# 1997 Corvette: Service Bulletin: Hatch Will Not Pop Up When Activated in Cold Weather

**Source:** Chevrolet Dealer Technical Service Bulletin

**Number:** 73-10-58

**Models:** 1997 Chevrolet Corvette

Figure 1

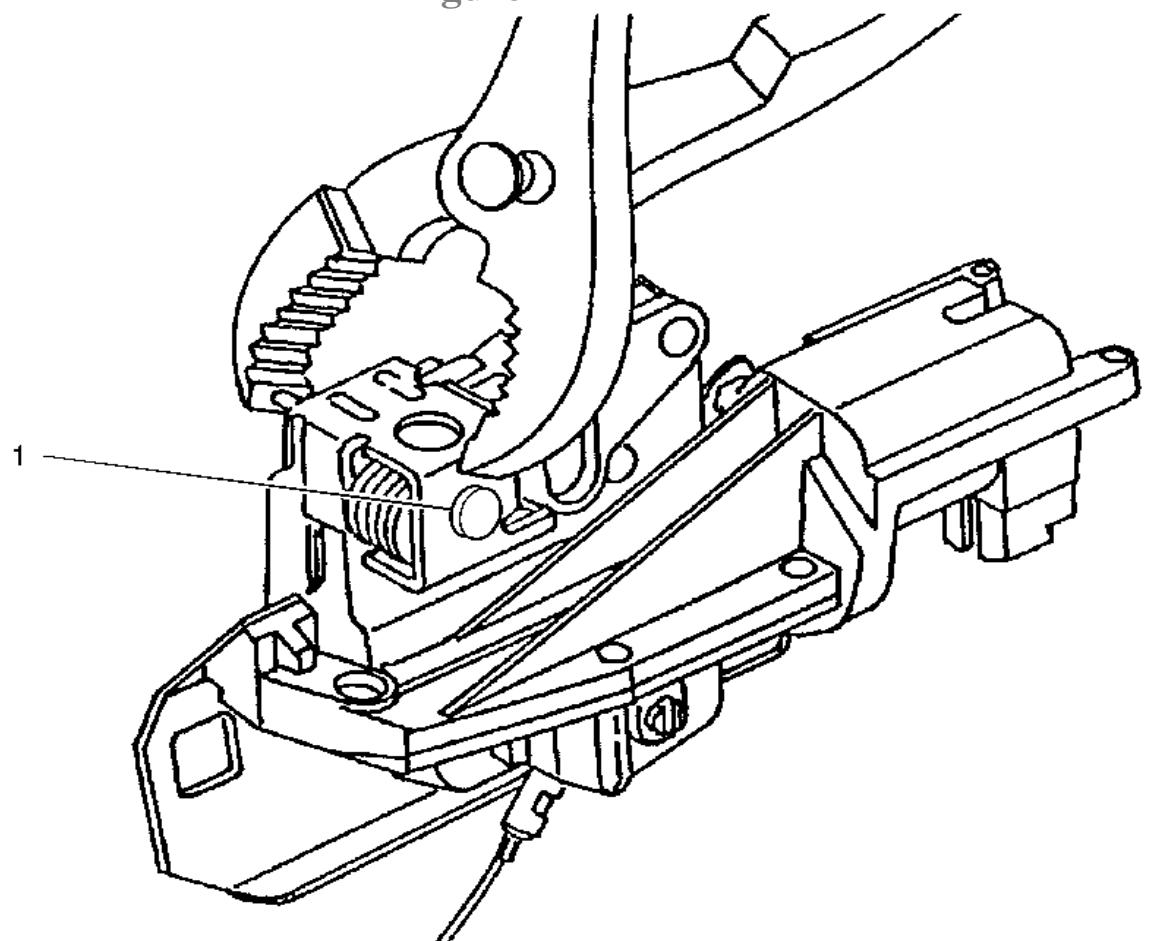
1. With hatch open, remove covers over latch assemblies.
2. Using a pair of pliers, drive the retaining pin forward, this will push the retaining pin off the Tinnerman nut (see Figure 1).
3. Take the pliers and drive the retaining pin in the other direction so that the Tinnerman nut can be removed (see Figure 2).
4. With the pin removed from the spring carrier, remove the carrier from the latch and use a screw driver to remove the pop up spring from the carrier.
5. Install a new spring in carrier and reinstall carrier to latch.
6. Reinstall retaining pin, Tinnerman nut and latch covers.
